**Land south of the A271 and east of the A22,
Lower Horsebridge, Hailsham, East Sussex,
BN27 4DN**

**Transport and Highways Statement of Common Ground between the Appellant
and East Sussex County Council.**

Planning Inspectorate Ref. APP/C1435/W/23/3335625

Report Title: Statement of Common Ground on Transportation

Title
VEHICLE TRACKING FOR 7.9m
EMERGENCY VEHICLE

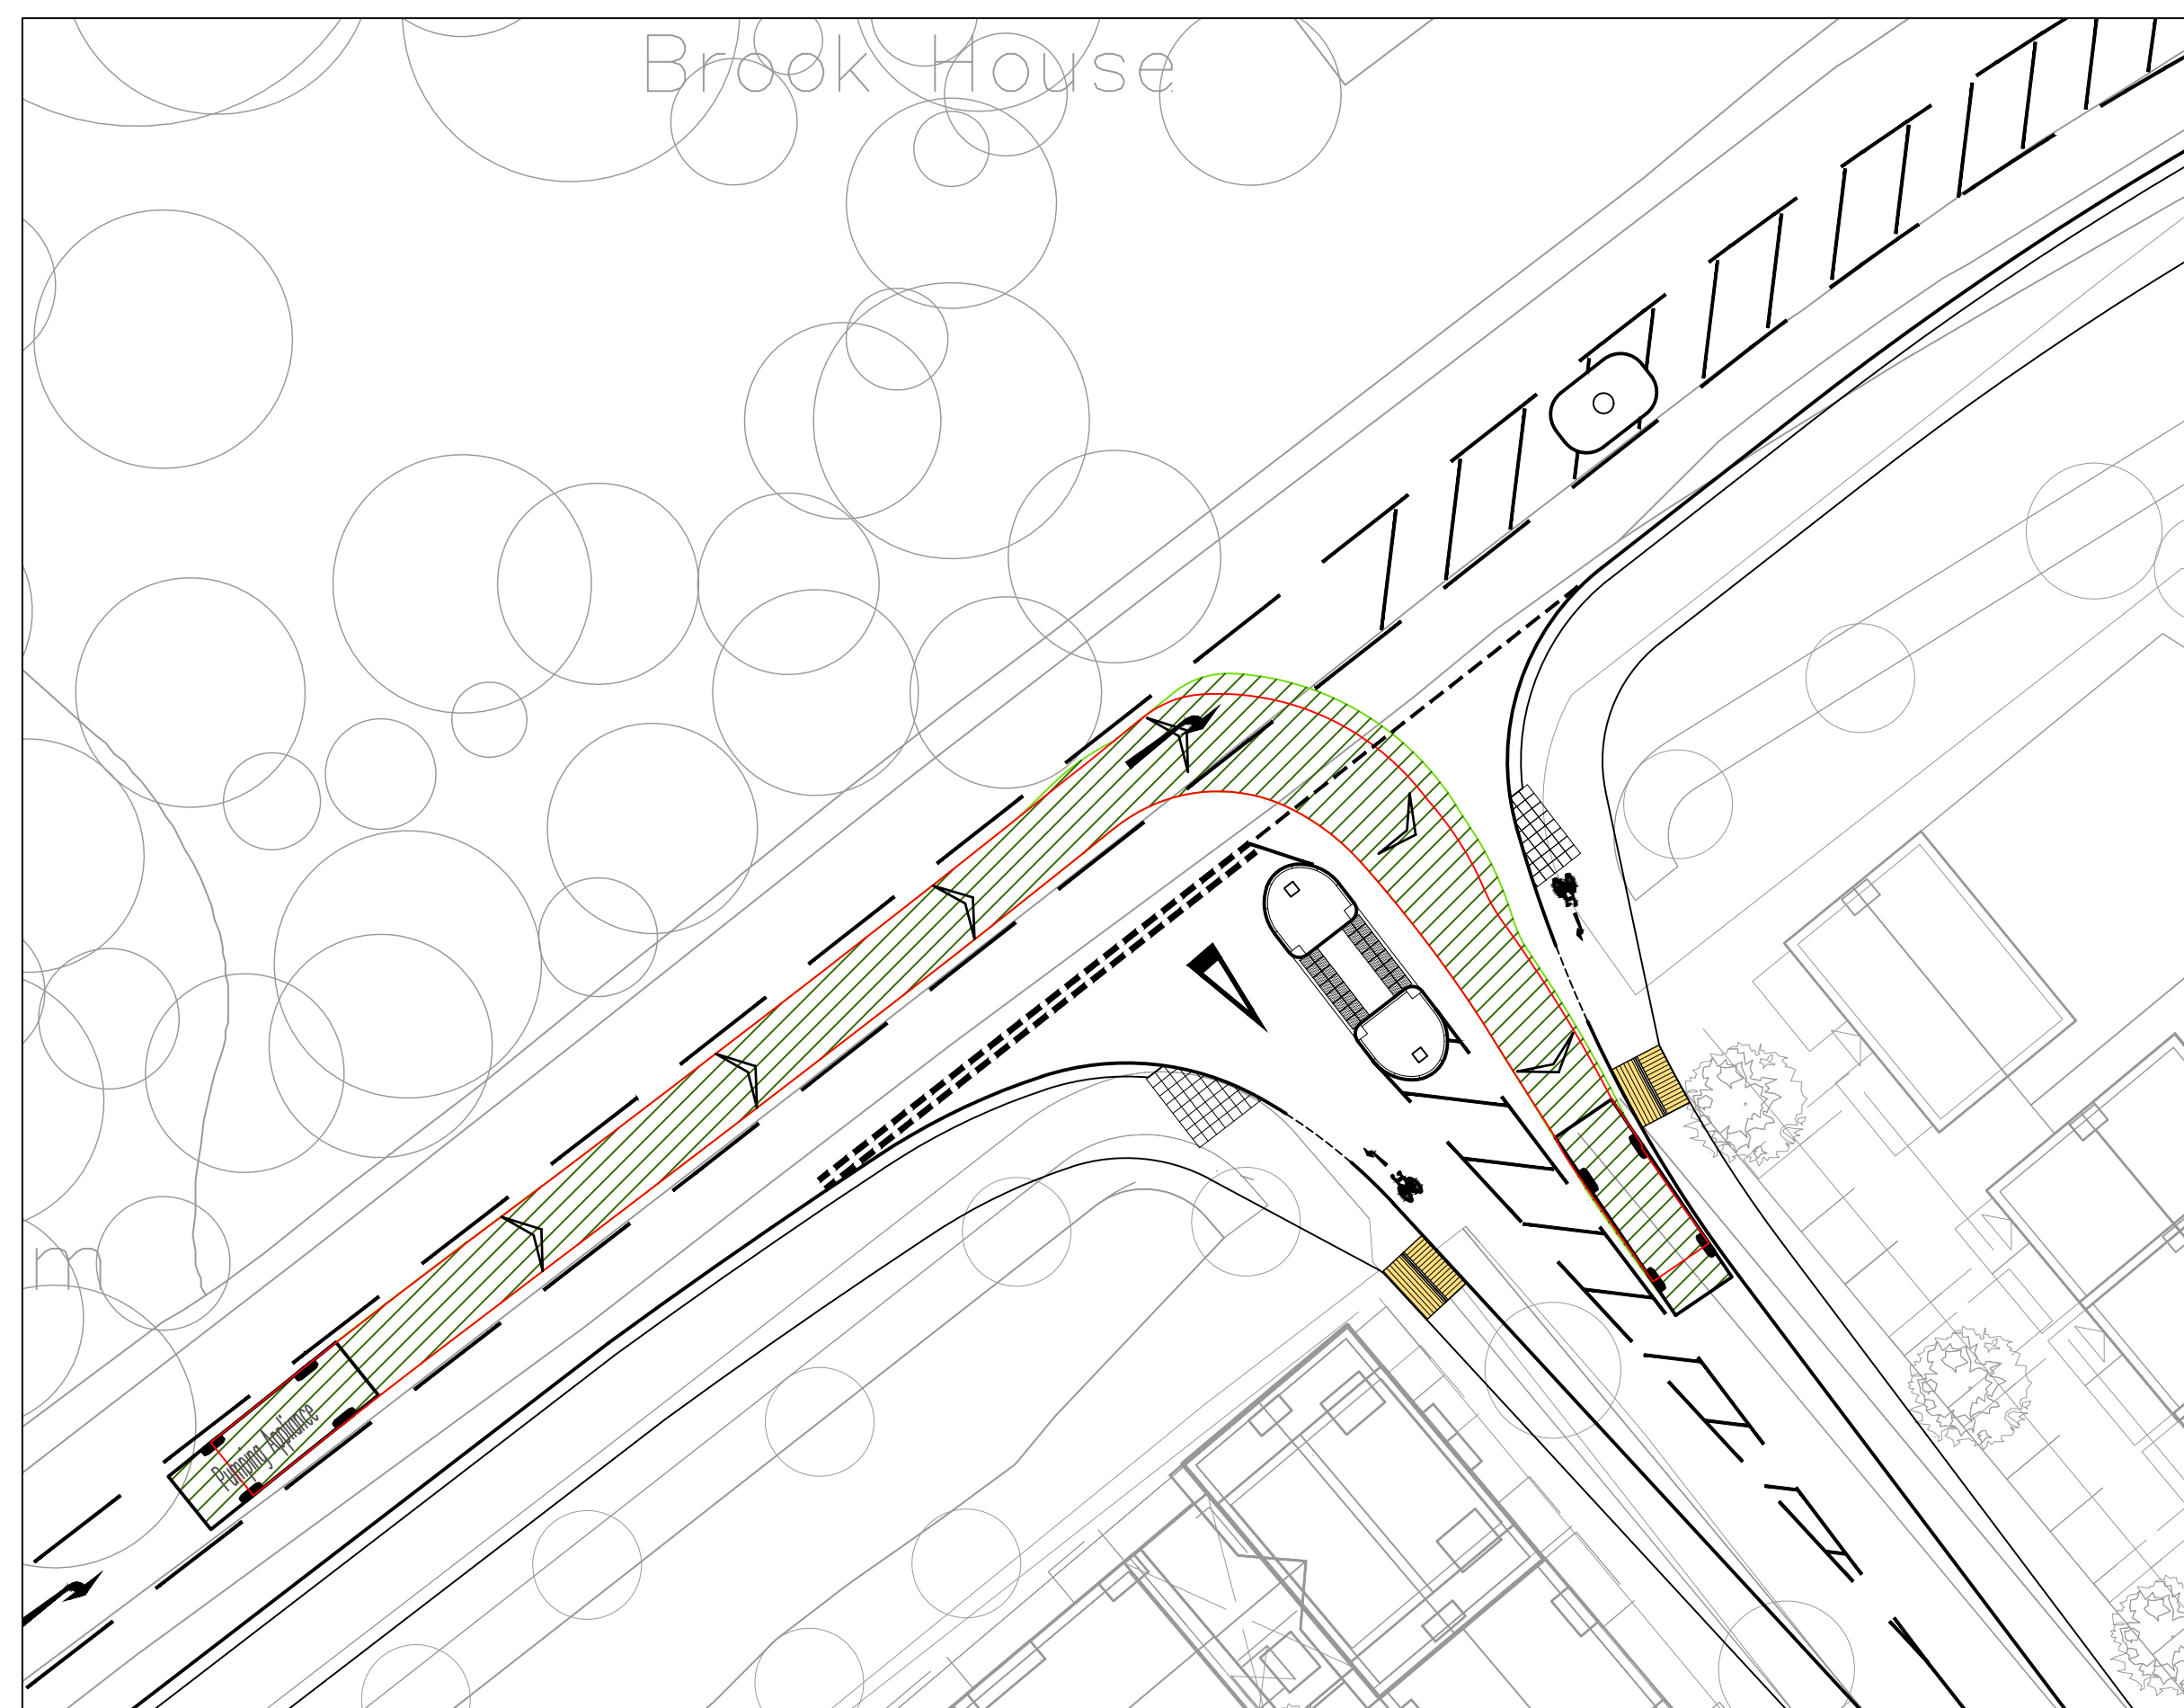
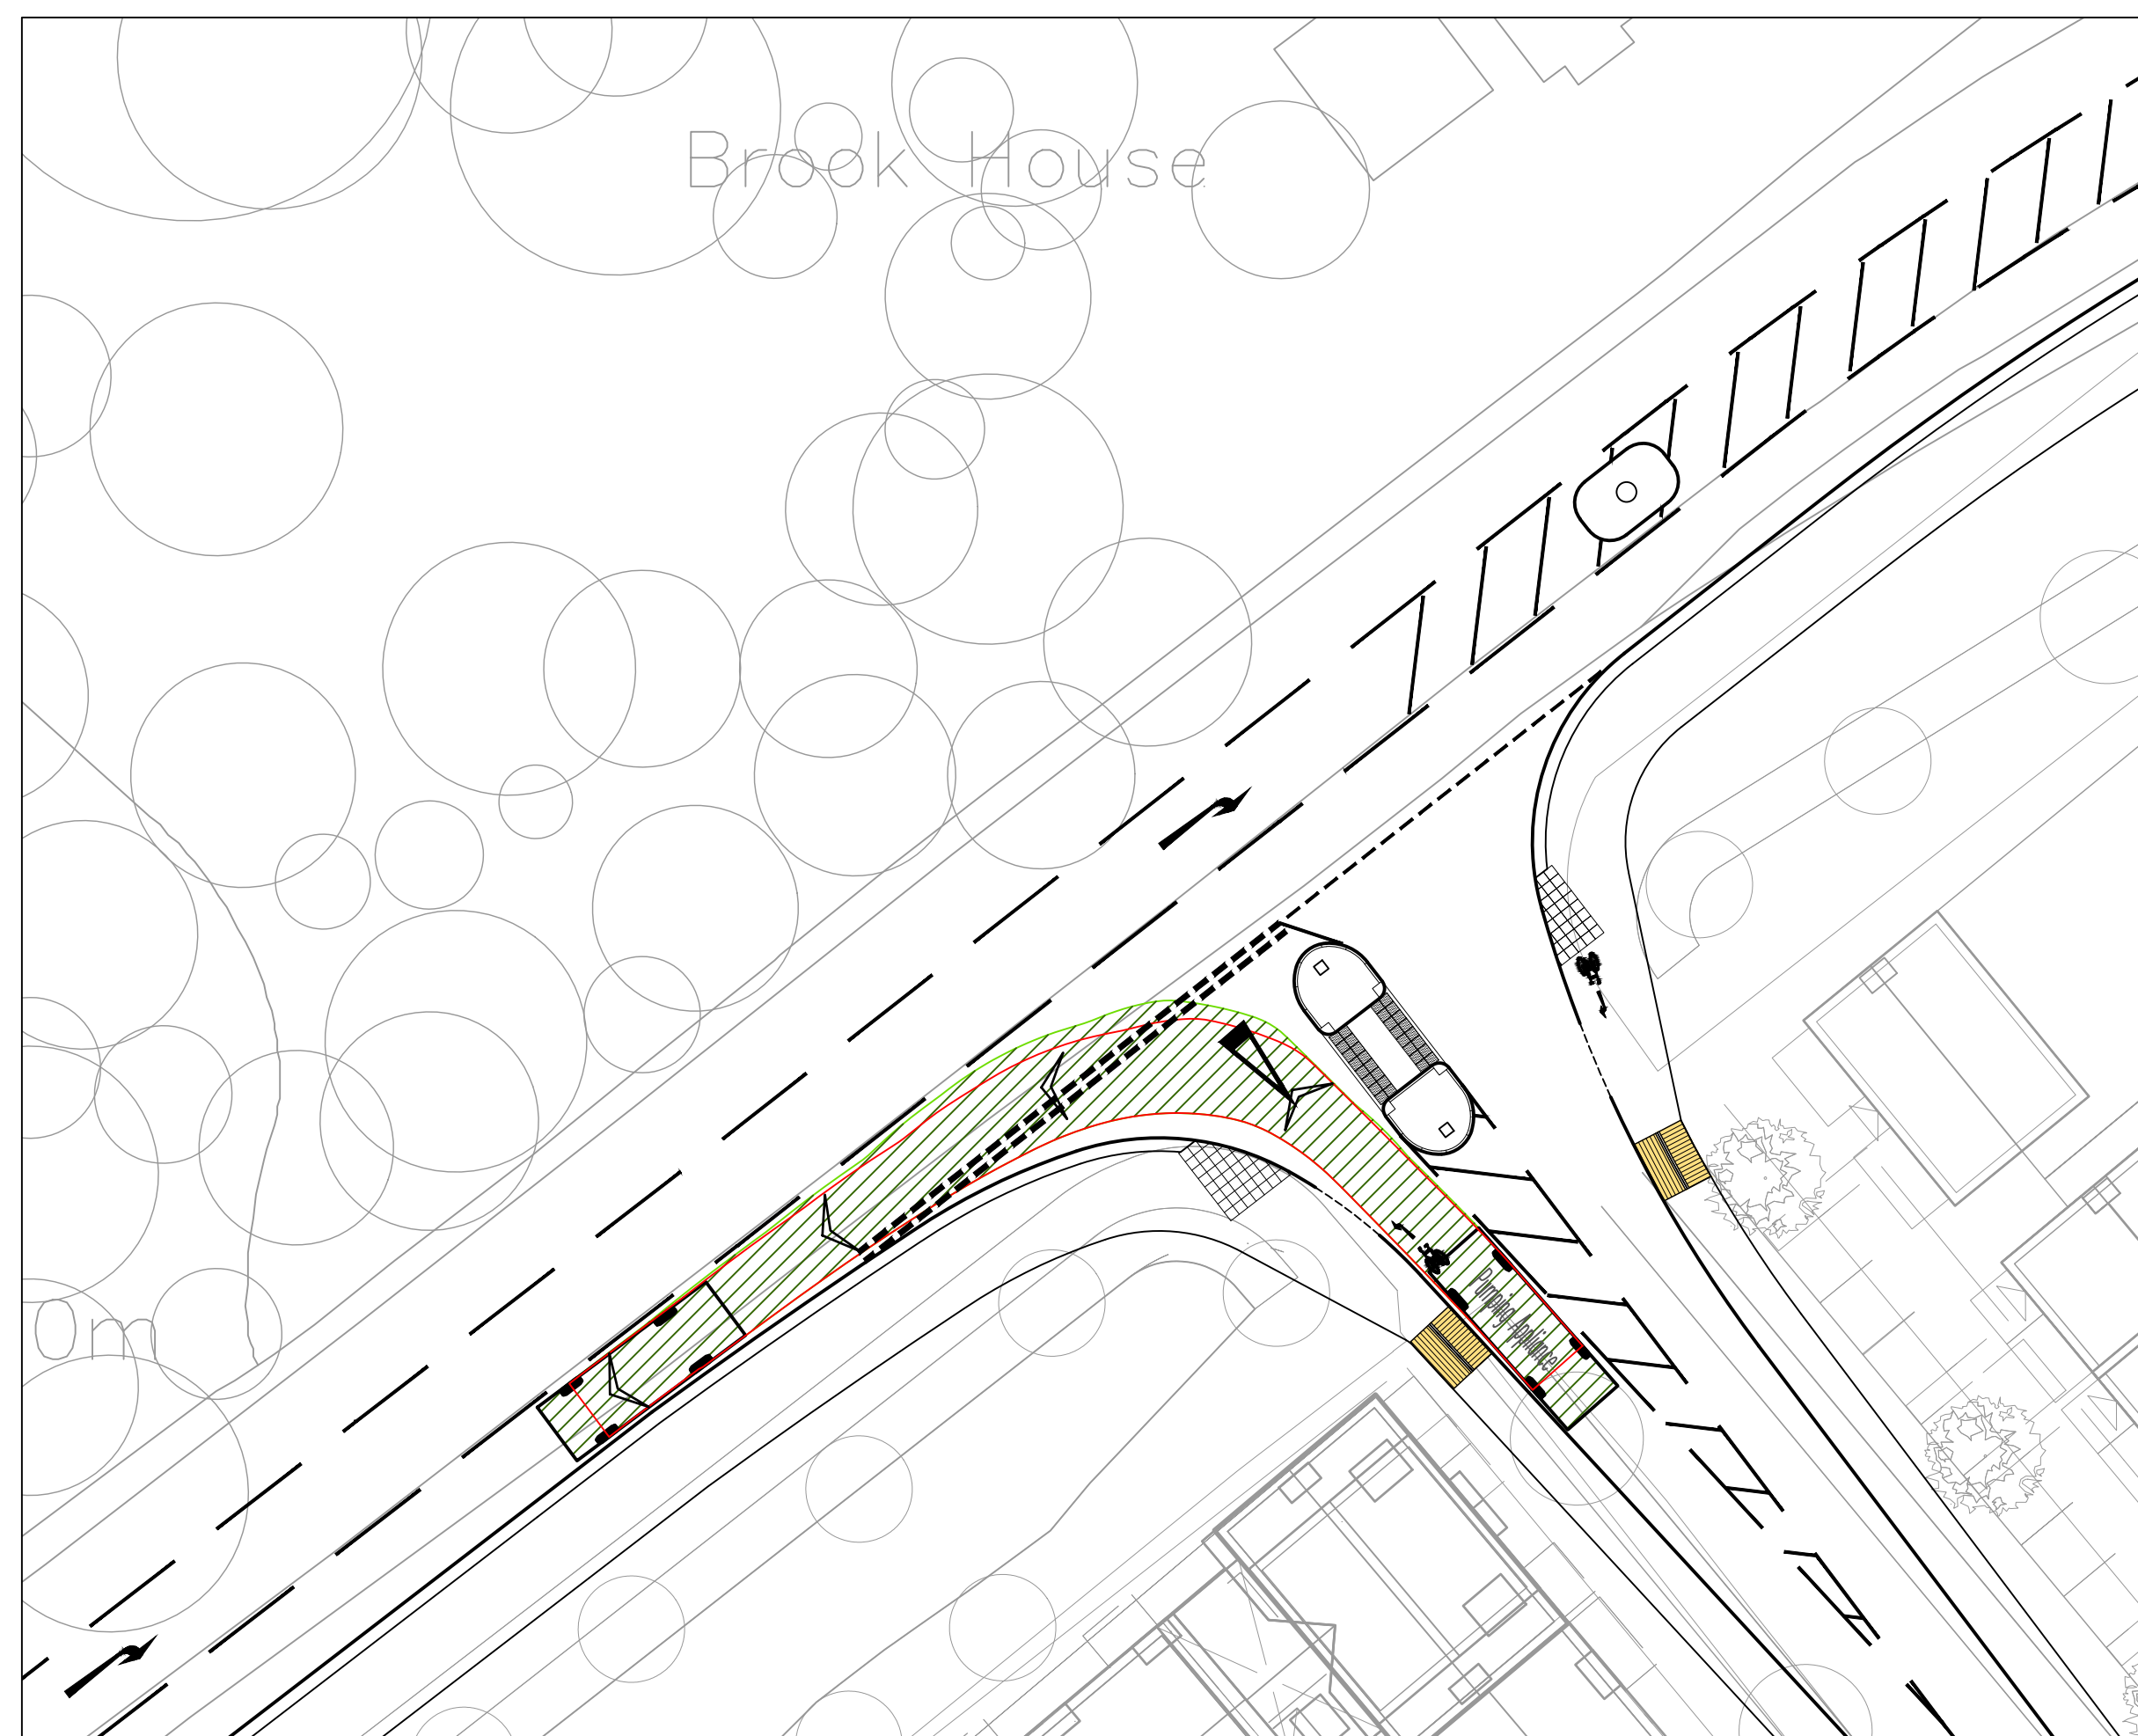
Tracking drawings have been submitted... showing how a refuse vehicle and fire appliance would access the site. The junction will be able to accommodate these vehicles, but I note the refuse vehicle is not the correct size. WDC use 12m long refuse vehicles. The plans should be amended.
